New M4/M4A1 Extractor Spring

Correct M4/M4A1 extractor spring is gold with a **black** insert

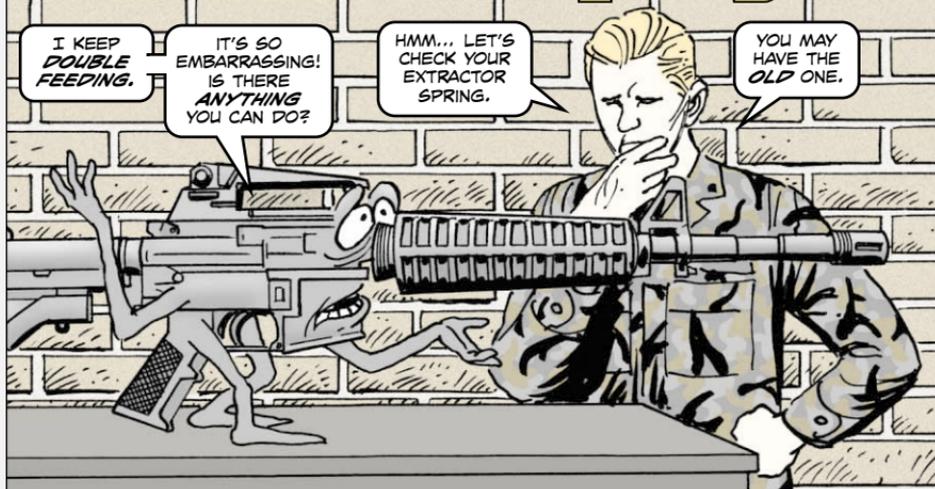
To improve the reliability of the M4/M4A1 carbine, the Army has gone to a new extractor spring assembly for the carbine's breech bolt assembly, whose NSN is now 1005-01-505-1035 because of the new extractor spring.

The new extractor spring assembly comes with NSN 1005-01-505-2886. It's gold colored with a black insert and will be added to TM 9-1005-319-23&P in Change 8.

The M16-series rifle will continue to use the extractor spring assembly that comes with NSN 1005-01-424-5899 and is dark and has a black insert.

All M4/M4A1s should have the new extractor spring assemblies installed by June 2005.
